Access Compliance Report

Public Rights-of-Way

Intersection ID: 45239	Main Street: BROOKWOOD_RD	Cross Street: CALDWELL_RD	Location: S
ADA ID: 6943C539ECA5	Ramp Type: Combination1	Initial Pass/Fail: Fail	Overall Compliance: No
		Severity Score: 22.5

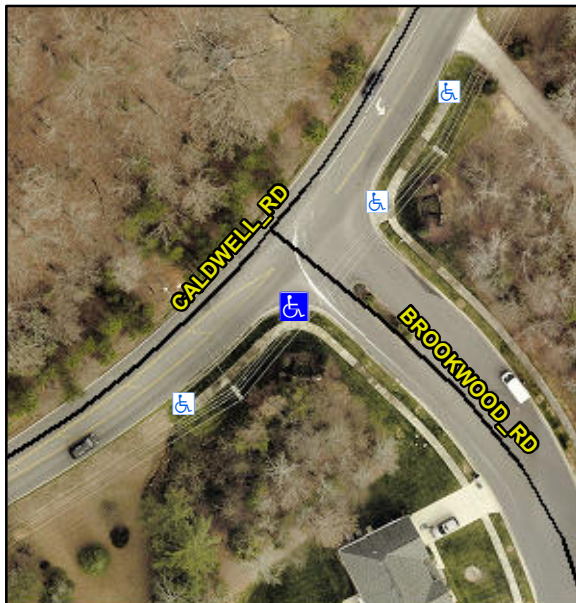
CURB GAP 1.0

Not Found, R304.5.1, R304.5.3, R304.3.2

Compliance	Description	Data	Compliance	Description	Data
N/A	Ramp Length LT (in)	34.5	N/A	Ramp Length RT (in)	34.5
Yes	Ramp Width LT (in)	55.0	Yes	Ramp Width RT (in)	55.5
Yes	Ramp Slope LT (%)	6.5	No	Ramp Slope RT (%)	10.1
No	Ramp XSlope LT (%)	4.4	No	Ramp XSlope RT (%)	3.0
N/A	Ramp Length (in)	76.0	Yes	Ramp Slope (%)	4.0
No	Ramp Width (in)	47.5	No	Ramp XSlope (%)	4.9
N/A	Flare Type LT	N/A	N/A	Flare Type RT	N/A
N/A	Flare Slope LT (%)	N/A	N/A	Flare Slope RT (%)	N/A
N/A	Flare Traversable LT?	N/A	N/A	Flare Traversable RT?	N/A
N/A	Landing Length (in)	N/A	N/A	DWS Provided?	N/A
N/A	Landing Width (in)	N/A	N/A	DWS Contrast?	N/A
N/A	Landing Slope (%)	N/A	N/A	DWS Length (in)	N/A
N/A	Landing X Slope (%)	N/A	N/A	DWS Full Width?	N/A
N/A	Landing Curb? (Y/N)	N/A	N/A	DWS Offset (in)	N/A
N/A	Shared Landing?	N/A			
N/A	Gutter Ponding?	N/A	N/A	Gutter Slope (%)	N/A
N/A	Gutter Lip Ht (in)	N/A	N/A	Gutter X Slope (%)	N/A
N/A	Painted X Walk1?	No	N/A	Painted X Walk2?	N/A

Remove & Replace Entire Ramp.
